SUBJECT: MINUTES FROM JULY 6, 1989 QUALITY ASSURANCE MEETING, AND JULY 6 AND 7, 1989 DESIGN CONTROL MEETING

ENCLOSURE 1

July 6, 1989

**DOE/NRC MEETING ON
ESF TITLE II DESIGN CONTROL PROCESS**

GHOST DANCE FAULT

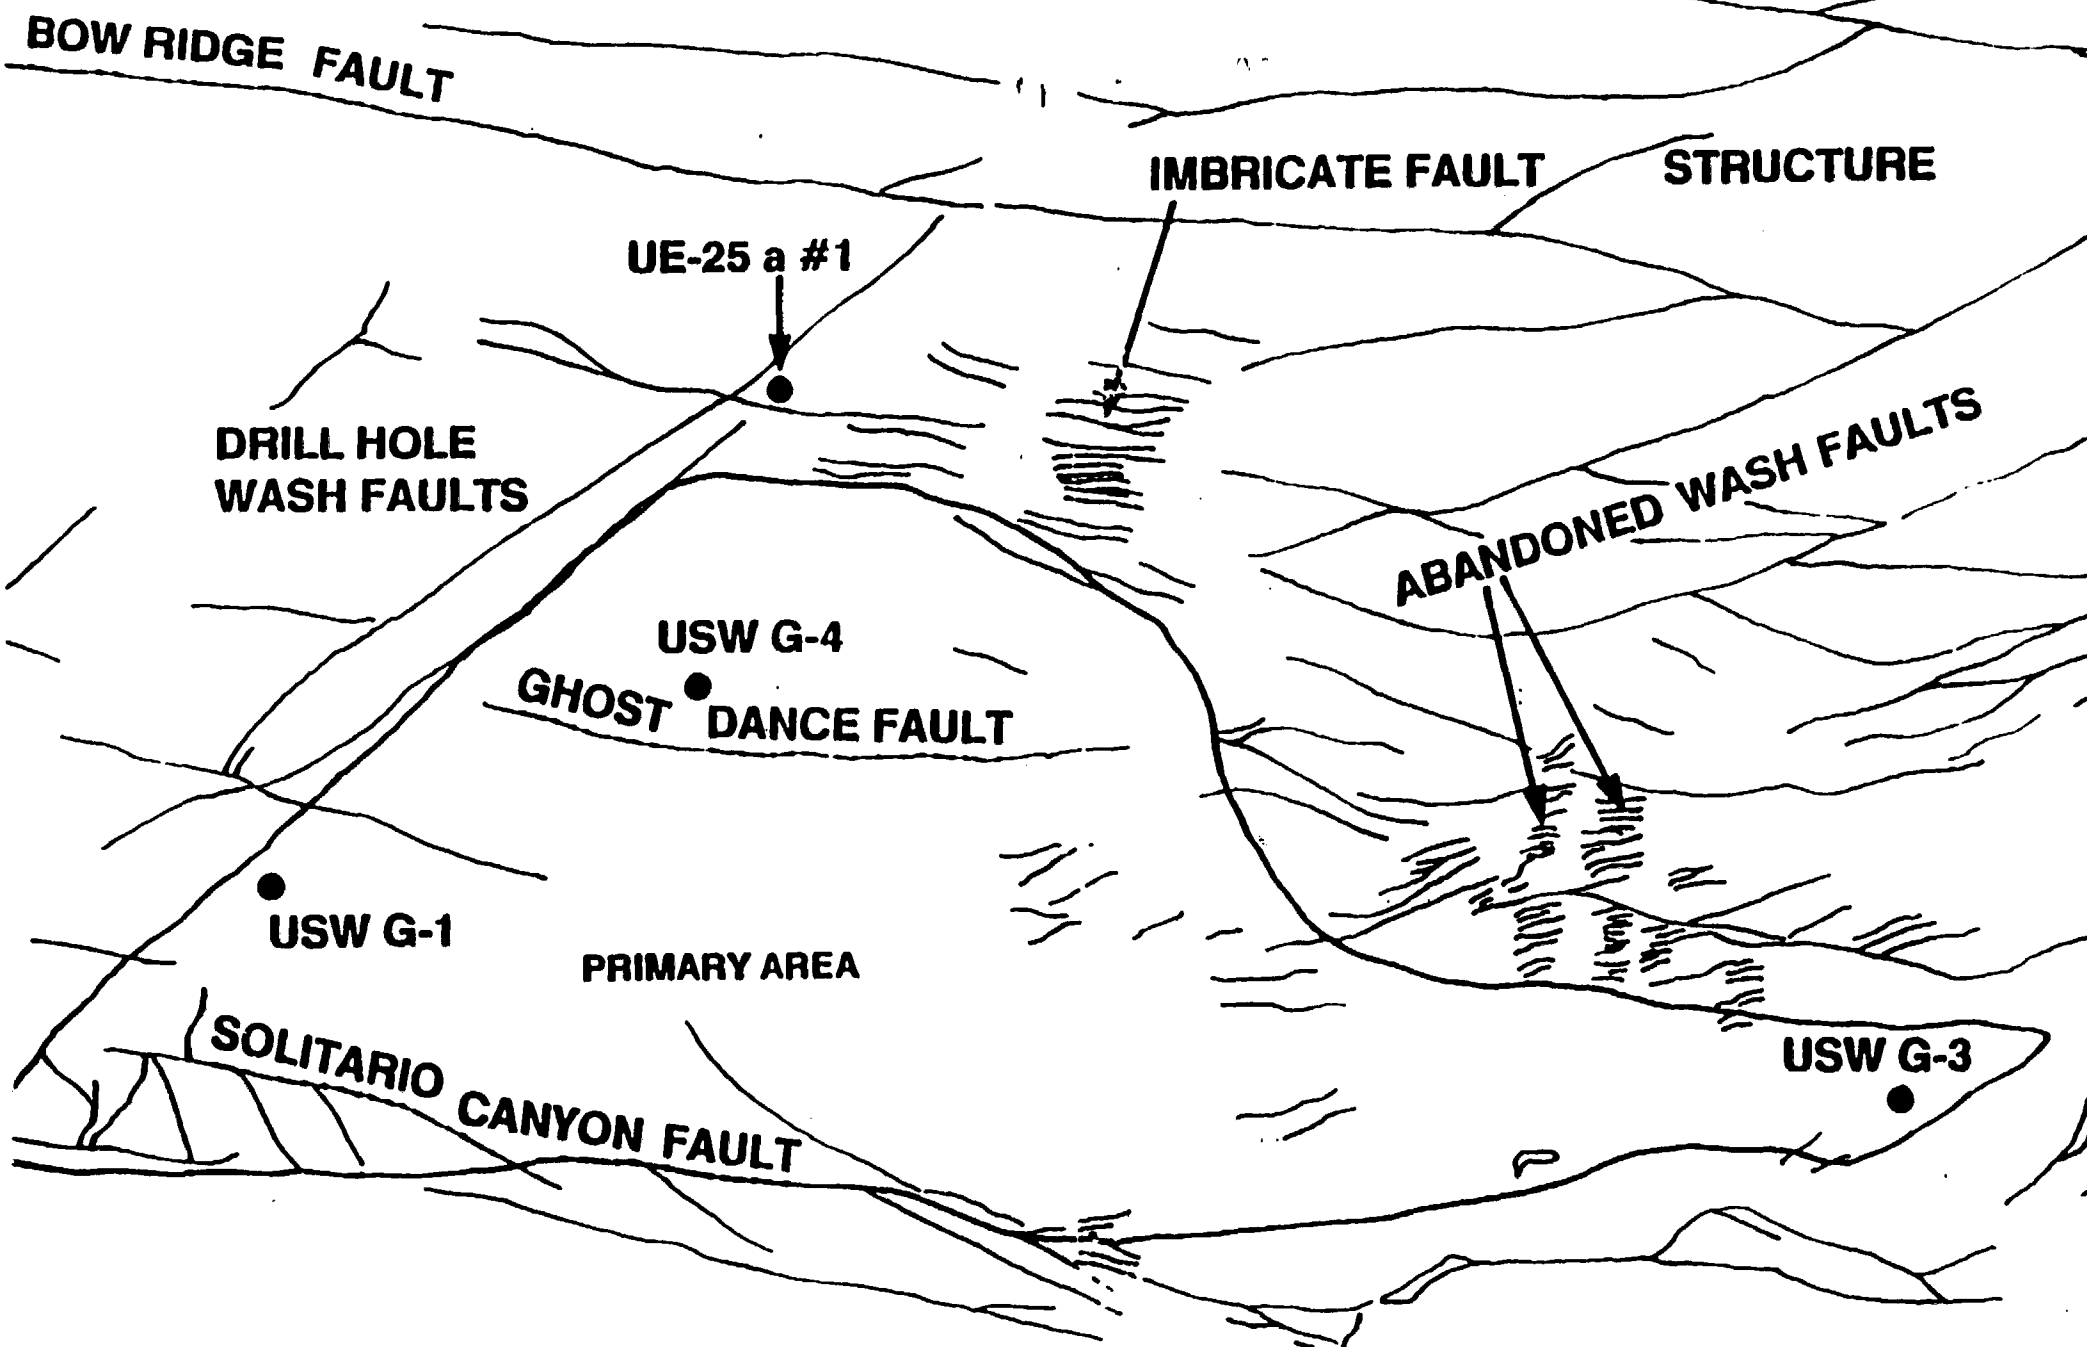
REPOSITORY EXPANSION BEYOND?

HYDROLOGIC SIGNIFICANCE?

GROUND SUPPORT IMPLICATIONS FOR REPOSITORY?
